Access Audit Site Report

Lake Colorado City State Park

Accessibility Evaluation

Inspection Date: 12/13/2021

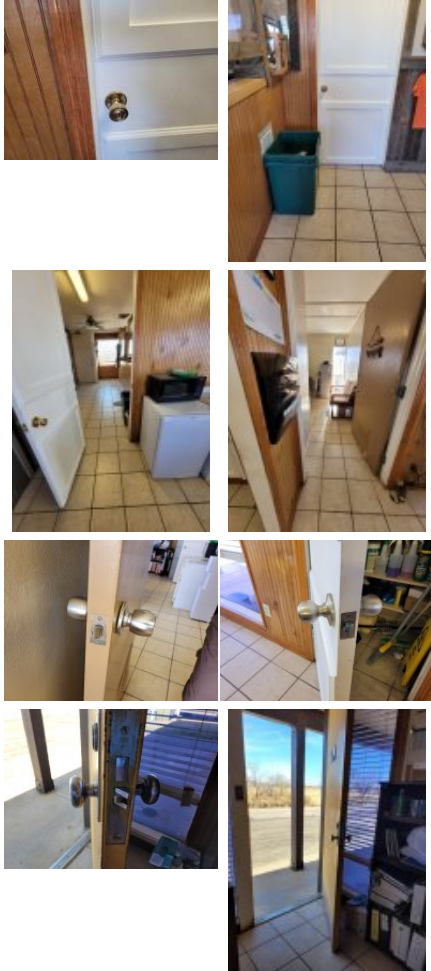
Finding Number	Area Description	Lat/Long	Finding	As Built	Recommendation	Citation	Photos	Figure																						
3	Headquarters : HQ Parking	[32.3183302 , -100.9364 321]	The accessible parking stall's access aisle contains a built up curb ramp which results in significant slopes greater than 2 percent. Surface slopes of accessible parking spaces and access aisles shall be the minimum possible and shall not exceed one unit vertical in 50 units' horizontal (2-percent slope) in any direction.	HQ - curb ramp in access aisle and stall; access aisle- 6.9%, stall - 10.5%	Remove built up curb ramp in access aisle and stall and create a curb ramp to be max running slope 8.33%, max cross slope 2.08%, having a top landing as wide as the ramp and 36" deep and side flares with a max slope 10%	2015 ABAAS Section: 502.4 2012 TAS Section: 502.4 2010 ADAS Section: 502.4																								
4	Headquarters : HQ Parking	[32.3183268 , -100.9364 268]	There are no van accessible parking stalls. 1 in every 6, minimum of one, required accessible stalls must be a van accessible stall. There are a total of 9 parking stalls in the parking lot that could be reasonably associated with this facility. There should be a minimum of 1 accessible stalls with a minimum of 1 being designed as van accessible.	HQ parking - 11' stall, 4'3" access aisle	Add van parking sign to 1 accessible stall and repaint stall and access aisle to 11' and 5' or 8' and 8' per the table.	2015 ABAAS Section: F208.2, F208.2.4 2012 TAS Section: 208.2, 208.2.4 2010 ADAS Section: 208.2, 208.2.4

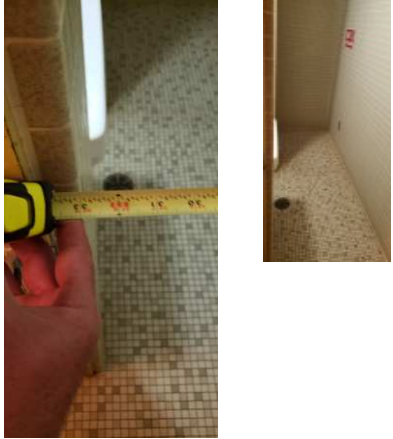
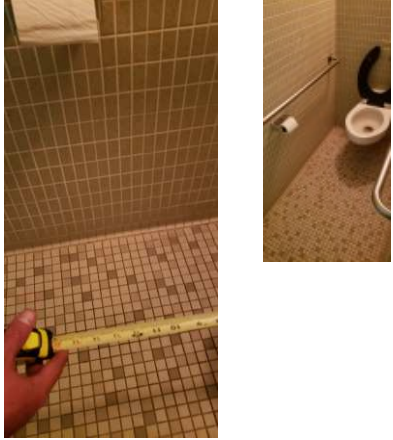
15	Headquarters : HQ Women's Restroom	[32.31572, -100.9417]	The restroom sign does not comply with one or more applicable requirements for the location, height, and properties of the sign.	Women's Restroom - no signage	Acquire and mount signage, including Braille and access symbol mounted on wall, latch side of door, 48" to baseline of lowest character and 60" to baseline of highest character.	2015 ABAAS Section: F216.2, 703.1, 703.2, 703.5, 703.6 2012 TAS Section: 216.2, 703.1, 703.2, 703.5, 703.6 2010 ADAS Section: 216.2, 703.1, 703.2, 703.5, 703.6		
16	Headquarters : HQ Women's Restroom	[32.31572, -100.9417]	The mirror is mounted too high. Mirrors must have the bottom edge of the reflecting surface a maximum of 40 inches above the floor if above a sink or counter. Mirrors not located above lavatories or countertops shall be installed with the bottom edge of the reflecting surface 35 inches maximum above the finish floor or ground.	Women's Restroom - mirror 46" aff	Lower mirror so reflective surface is max 40" aff	2015 ABAAS Section: 603.3 2012 TAS Section: 603.3 2010 ADAS Section: 603.3

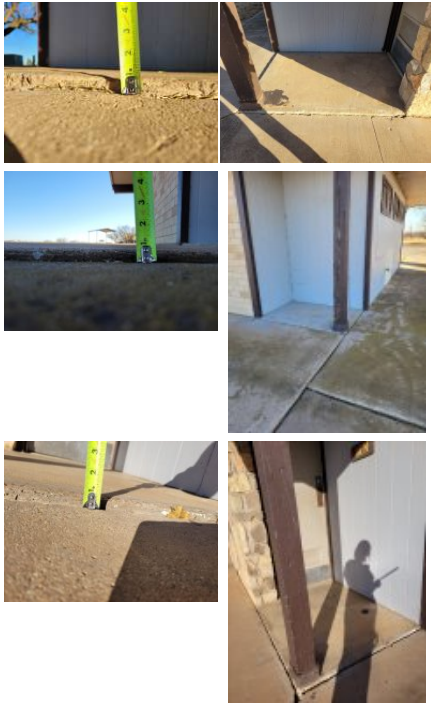
46	Park Site: Park Elements	[32.338556, -100.9294892]	Where picnic facilities contain two or fewer picnic units, each picnic unit shall provide mobility features complying with F245.2.	Group shelter at boat ramp - no route to water spigot or grill	Create an ORAR from shelter to water spigot and grill as a smart practice.	2015 ABAAS Section: F245.2.1

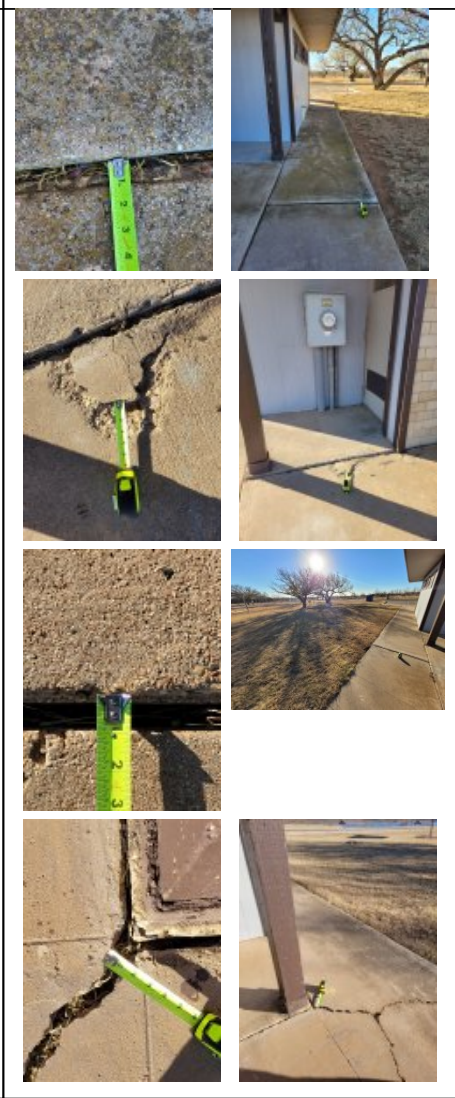
49	Park Site: Boat Ramp	[32.3390154 , -100.9288985]	There are no accessible parking stalls. Each lot where parking is provided for the public as clients, guests or employees, shall provide accessible parking and shall be located on the shortest accessible route of travel from adjacent parking to an accessible entrance. There are a total of 28 parking stalls in the parking lot that could be reasonably associated with this facility. There should be a minimum of 2 accessible stalls with a minimum of 1 being designed as van accessible.	Boat Ramp Parking has 0 of 28 accessible stalls	Create one or more 8' accessible parking stalls, with one 5' adjacent access aisle, with proper signage and striping based on the total number of stalls	2015 ABAAS Section: F208.2 2012 TAS Section: 208.2 2010 ADAS Section: 208.2

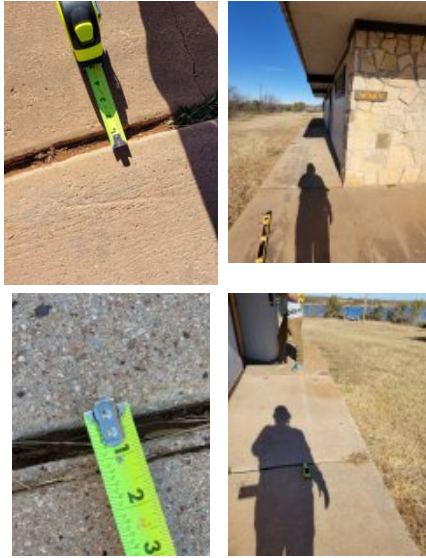
78	Park Site: Restroom Building 5 Boat Ramp - Men's	[32.31572, -100.9417]	Minimum maneuvering clearances at doors and gates shall comply with 404.2.4. Maneuvering clearances shall extend the full width of the doorway and the required latch side or hinge side clearance. The threshold has a vertical change greater than 1/4 inch high. The threshold at a doorway shall be no higher than 1/2 inch. Changes in level between 1/4 inch and 1/2 inch must be beveled at 1:2 or less. 1/4 inch is the maximum vertical rise. Exterior doors are recommended to be maintained at 8.5 lbf as a smart practice. Force is to be measured at the operating hardware or 30 inches from the hinges, whichever is greater.	Mens Restroom Door - 8" clearance on the pull side, 25# push, concrete in front of door deteriorated	For all doors along the public circulation route, provide required maneuvering clearance on push and pull side of doors For all doors along the public circulation route, repair, bevel, or ramp CILs at door entries to max .25" For all doors along the public circulation route, inspect, adjust, and maintain 8.5 lbf to open exterior doors as a smart practice	2010 ADAS Section: 404.2.3, 404.2.7, 404.2.4, 404.2.11, 404.2.11 Exception

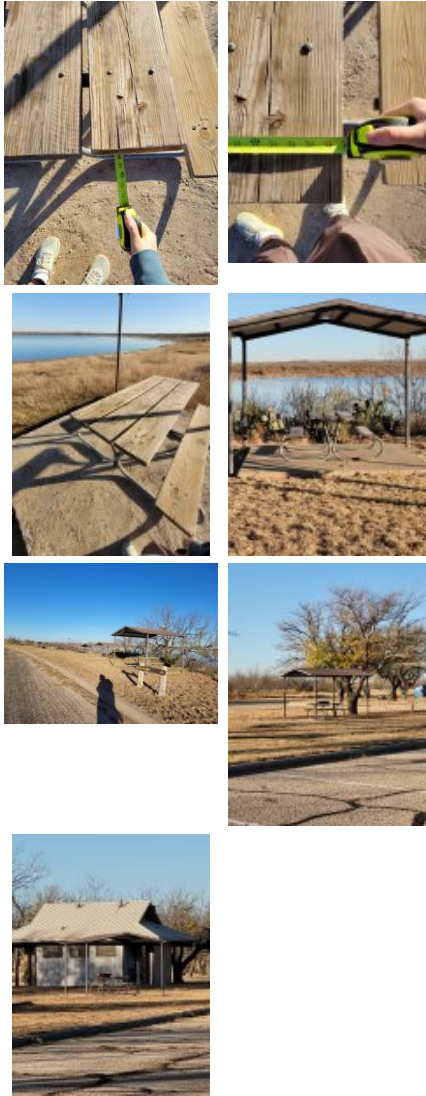
99	Park Site: Restroom Building 3 Near Fishing Pier - Women's	[32.31572, -100.9417]	The side grab bars are not in the correct location. Grab bars on the side wall must be installed so that the end closest to the rear wall is maximum 12" from the rear wall. The end furthest from the rear wall must be mounted minimum 54" from the rear wall.	Women's Restroom - both 52" from rear wall	Remount side grab bar to max 12" from the rear wall at the close end and min 54" on the far end, and 33" to 36" aff.	2015 ABAAS Section: 604.5.1 2012 TAS Section: 604.5.1 2010 ADAS Section: 604.5.1

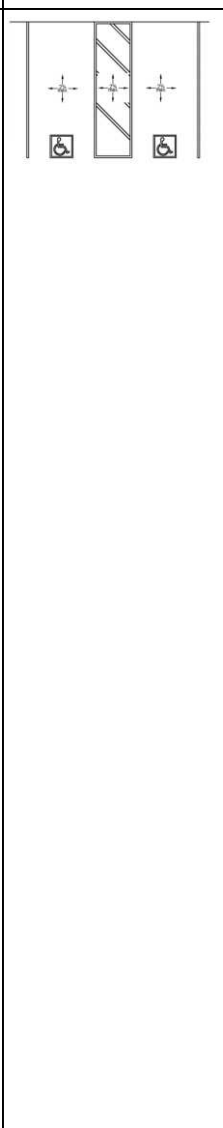
224	Campsites: Restroom Building 1 Rolling Hills - Men's	[32.31572, -100.9417]	The side grab bars are not in the correct location. Grab bars on the side wall must be installed so that the end closest to the rear wall is maximum 12" from the rear wall. The end furthest from the rear wall must be mounted minimum 54" from the rear wall.	Men's Restroom - 41" from rear wall	Remount side grab bar to max 12" from the rear wall at the close end and min 54" on the far end, and 33" to 36" aff. See previous finding for cost.	2015 ABAAS Section: 604.5.1 2012 TAS Section: 604.5.1 2010 ADAS Section: 604.5.1
